Work Order ID 158751

DESIGN <i>CP</i>	DRAWN BY <i>CP</i>	DART AEROSPACE LTD HAWKESBURY, ONTARIO, CANADA	
CHECKED <i>#</i>	APPROVED <i>#</i>	DRAWING NO. D3016	REV. A SHEET 1 OF 3
DATE 01.05.18		TITLE SEAT FRAME ASSEMBLY	SCALE NTS
A	01.05.18	NEW ISSUE

DRAWING NO. D3016	TITLE SEAT FRAME ASSEMBLY	REV. A	DART AEROSPACE LTD ENGINEERING ORDER	D.E.O. NO. D3016-A-1	SHEET NO. SHEET 1 OF 1	SCALE NTS
DRAWN <i>1</i>	CHECKED <i>JP</i>	MFG. APPR. <i>RE</i>	APPROVED <i>WAP</i>	DE APPR. <i>TH</i>		
DATE 10.01.29	DATE 10.01.29	DATE 10.01.29	DATE 10.01.29	DATE 10.01.29	DATE 10.01.29

TO REVISE D3016-11 SADDLE'S HOLE SIZES

D3016-11 SADDLE

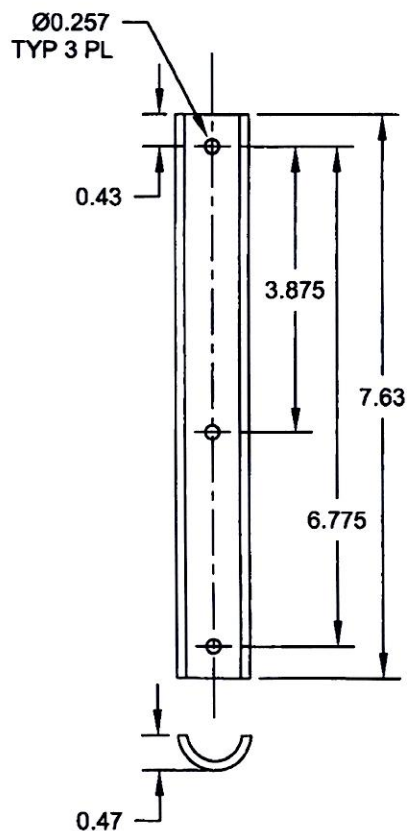
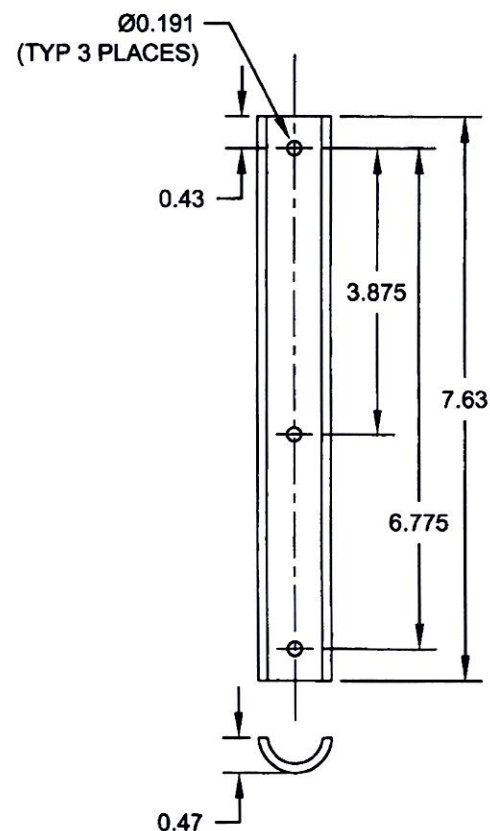
DETAIL D3016-11 SADDLE (SHEET 3): Ø0.257 TYP 3 PL WAS Ø0.191 (TYP 3 PLACES) AS SHOWN:
